RE: **Lot 5 Block 1 SAD 227**  
**6615 Rimrock Dr. NW**  
**Grading and Drainage Plan**  
**Engineers Stamp Date 1/30/20 (D10D017)**  
**Pad Certification Dated 1/30/20**

Based upon the information provided in your submittal received 1/30/20, this plan cannot be approved for Pad Certification until the following comments are addressed.

| DAVID SOULE<br>P.E. #14522   | GRADING AND DRAINAGE PLAN | 6615 RIM ROCK RD REVISED.DWG |

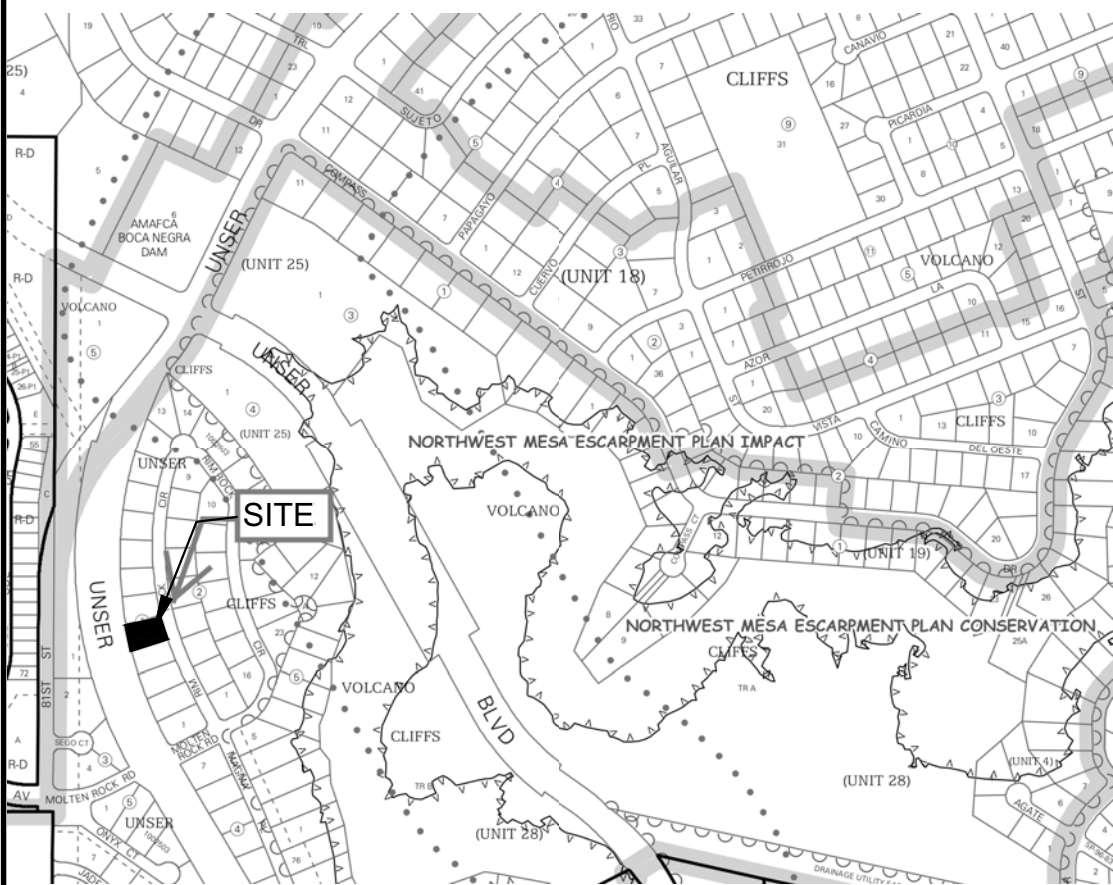
- Remove the dirt and debris from the street and sidewalk. Make sure that it is swept clean.
